Consultant Advice Notice

Thornbury House – 716 High Street, Thornbury VIC 3071

Addendum to Acoustic Town Planning Report

PLAN LEVEL 5

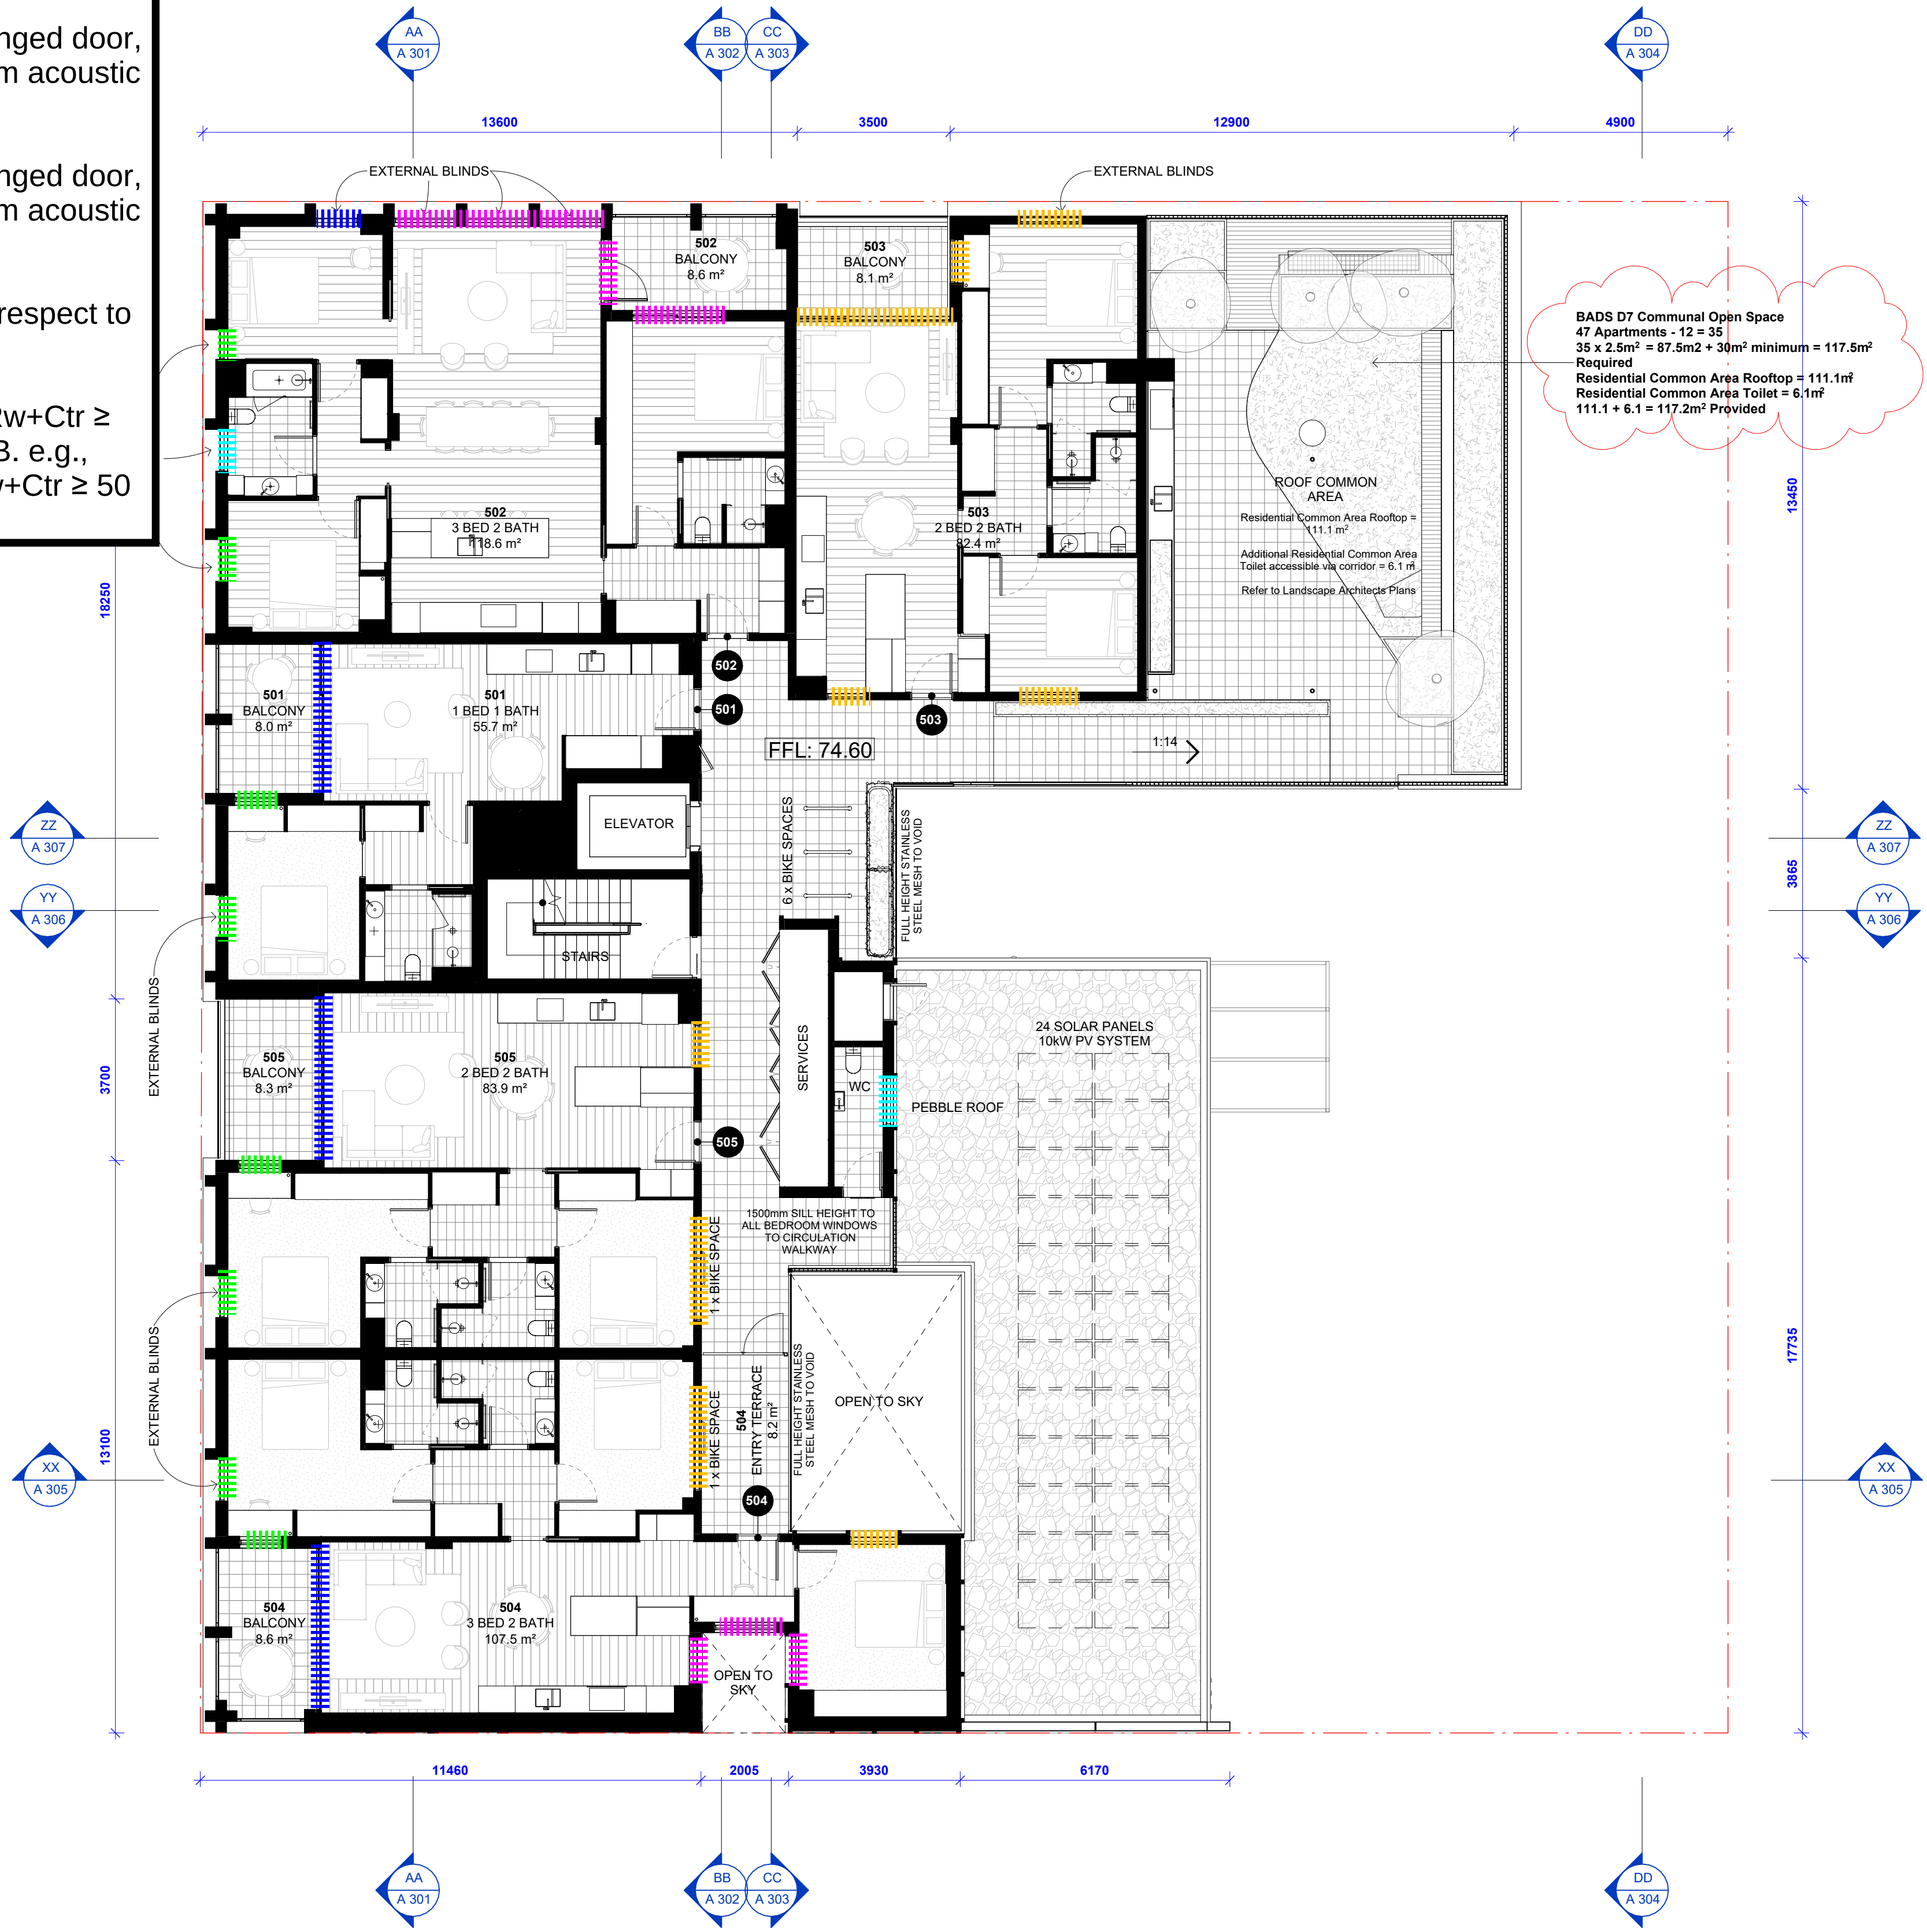
Fixed/awning glazing, sliding door or hinged door, including any frames and seals to have a minimum acoustic rating of Rw 40.

Fixed/awning glazing, sliding door or hinged door, including any frames and seals to have a minimum acoustic rating of Rw 38.

Fixed/awning glazing, sliding door or hinged door, including any frames and seals to have a minimum acoustic rating of Rw 36.

Fixed/awning glazing, sliding door or hinged door, including any frames and seals to have a minimum acoustic rating of Rw 32.

Opaque sections of the façade shall be rated to $Rw+Ctr \geq$ the glazing performance requirement (Rw) + 10dB. e.g., opaque section of the facade shall be rated to $Rw+Ctr \geq 50$ proximate to Rw 40 rated glazing.

PLAN LEVEL 6

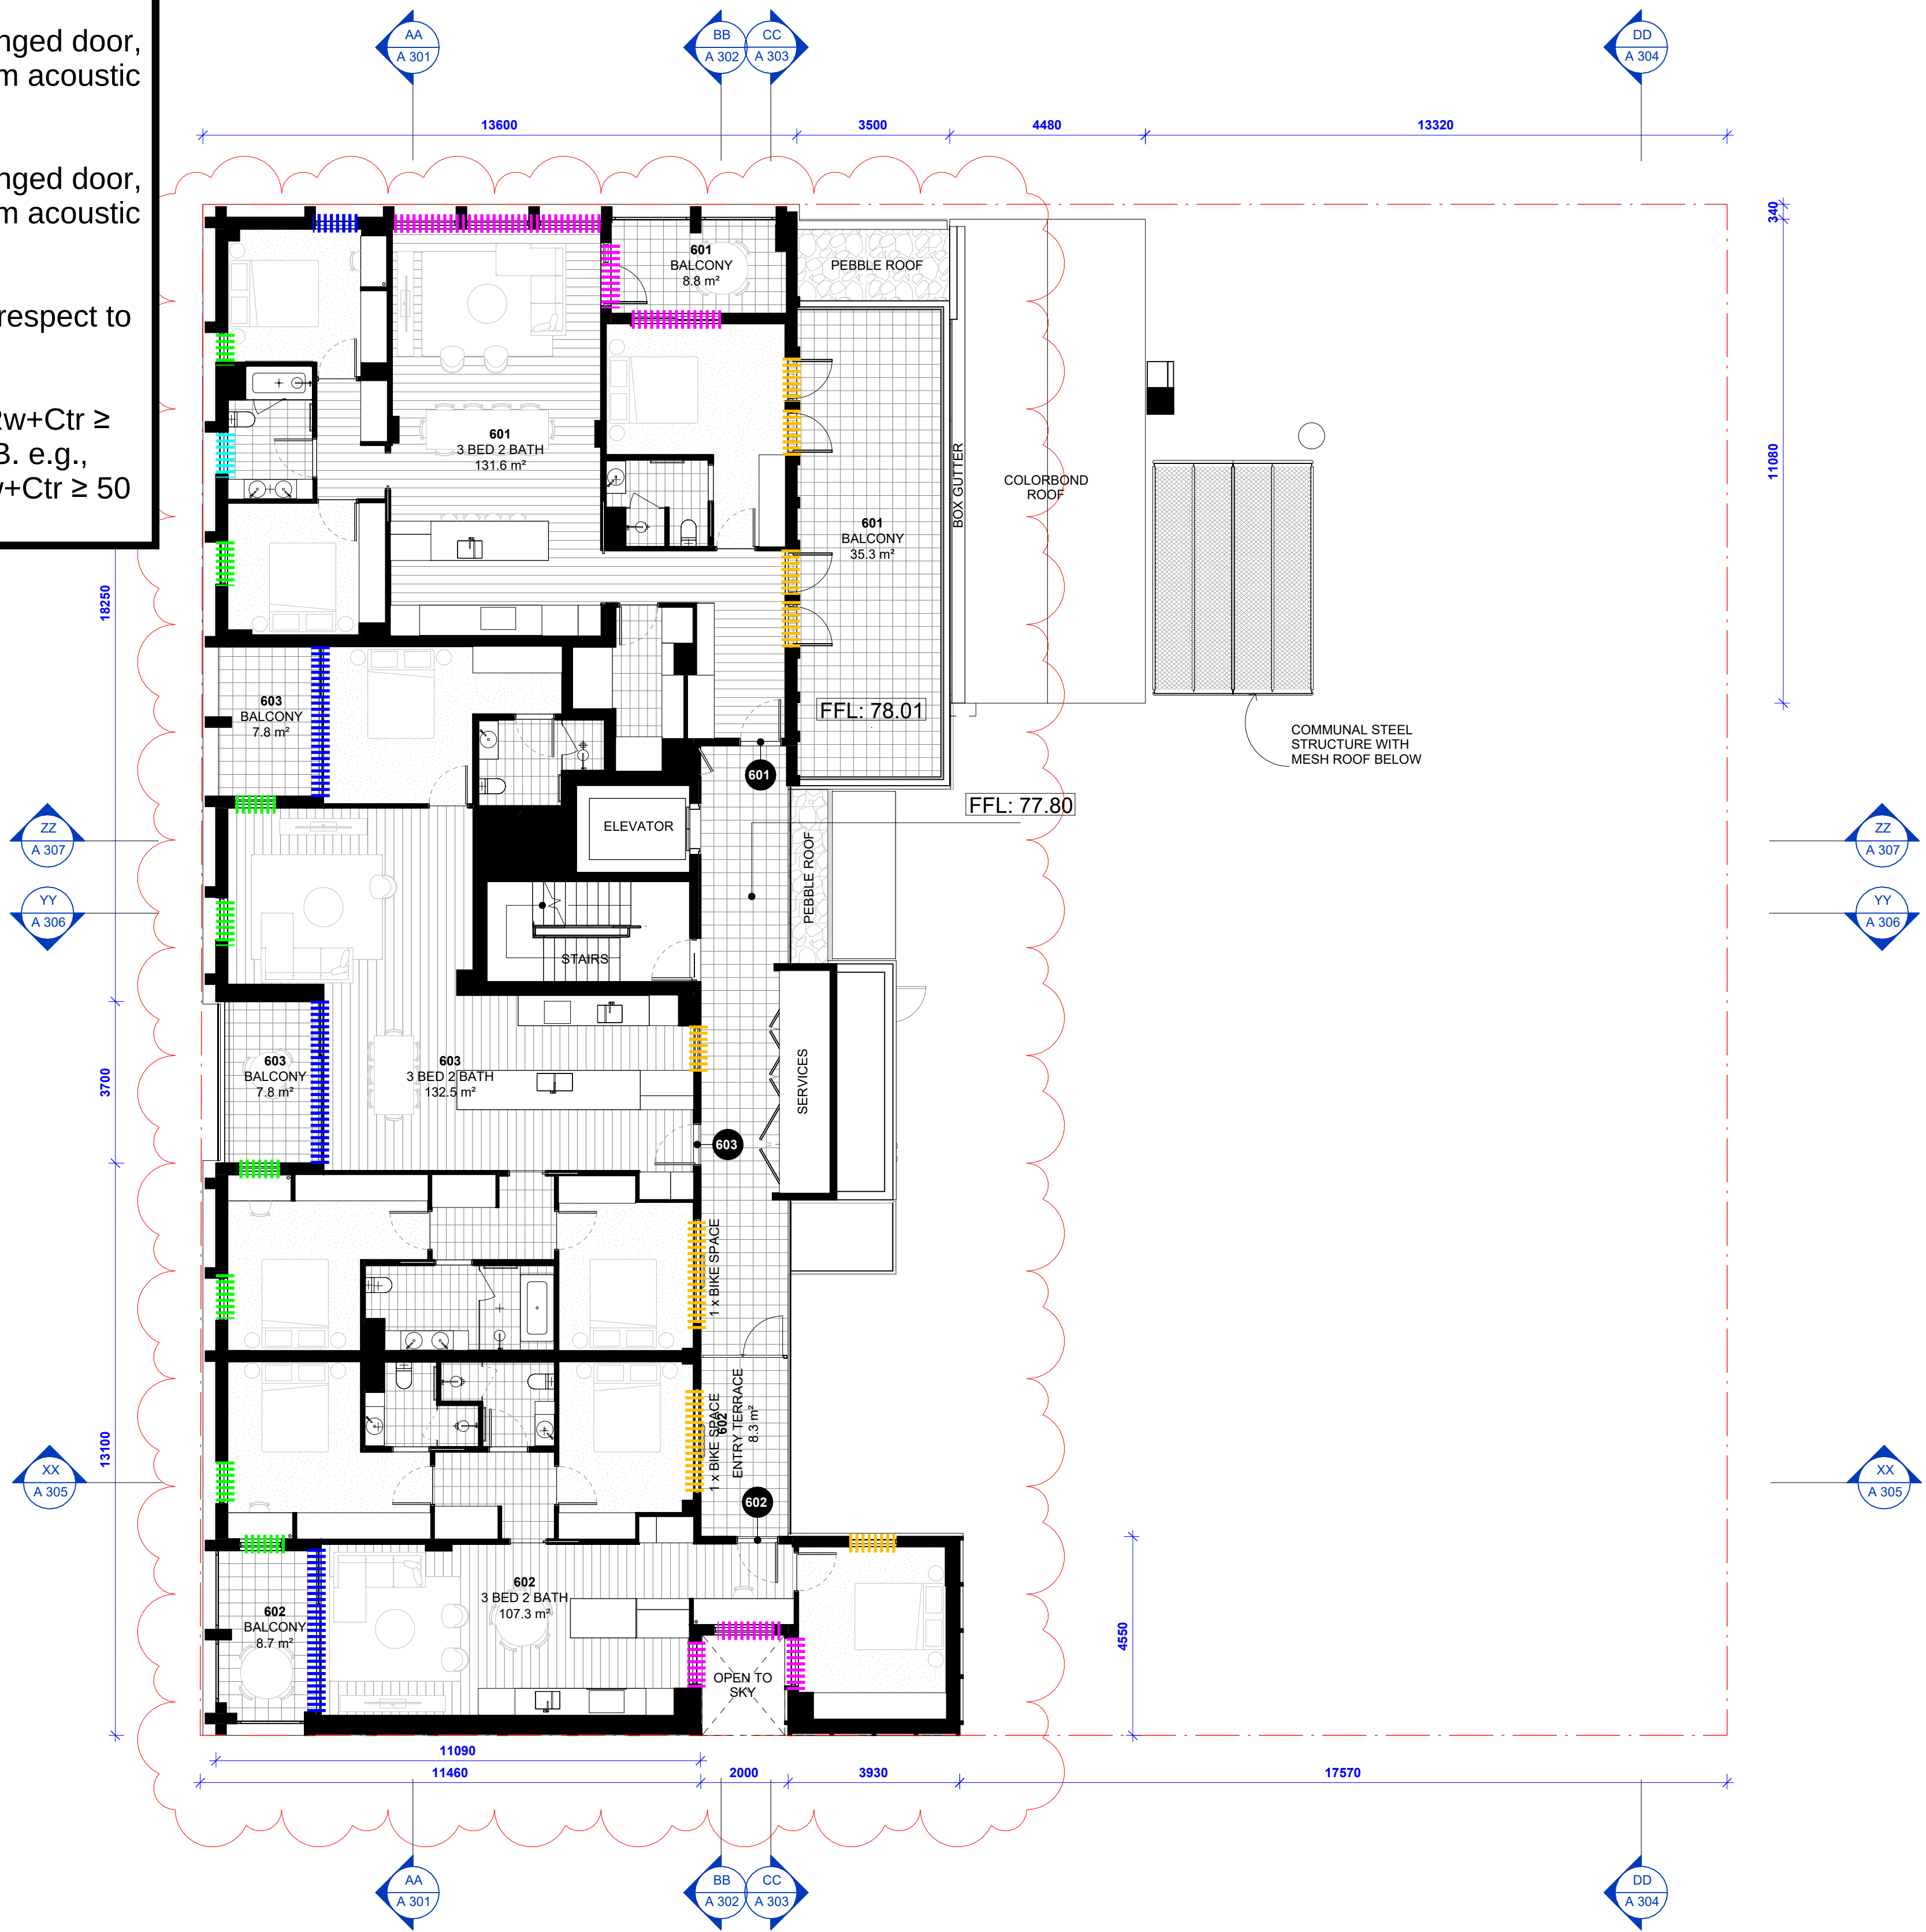
Fixed/awning glazing, sliding door or hinged door, including any frames and seals to have a minimum acoustic rating of Rw 40.

Fixed/awning glazing, sliding door or hinged door, including any frames and seals to have a minimum acoustic rating of Rw 38.

Fixed/awning glazing, sliding door or hinged door, including any frames and seals to have a minimum acoustic rating of Rw 36.

Fixed/awning glazing, sliding door or hinged door, including any frames and seals to have a minimum acoustic rating of Rw 32.

Opaque sections of the façade shall be rated to $Rw+Ctr \geq$ the glazing performance requirement (Rw) + 10dB. e.g., opaque section of the facade shall be rated to $Rw+Ctr \geq 50$ proximate to Rw 40 rated glazing.
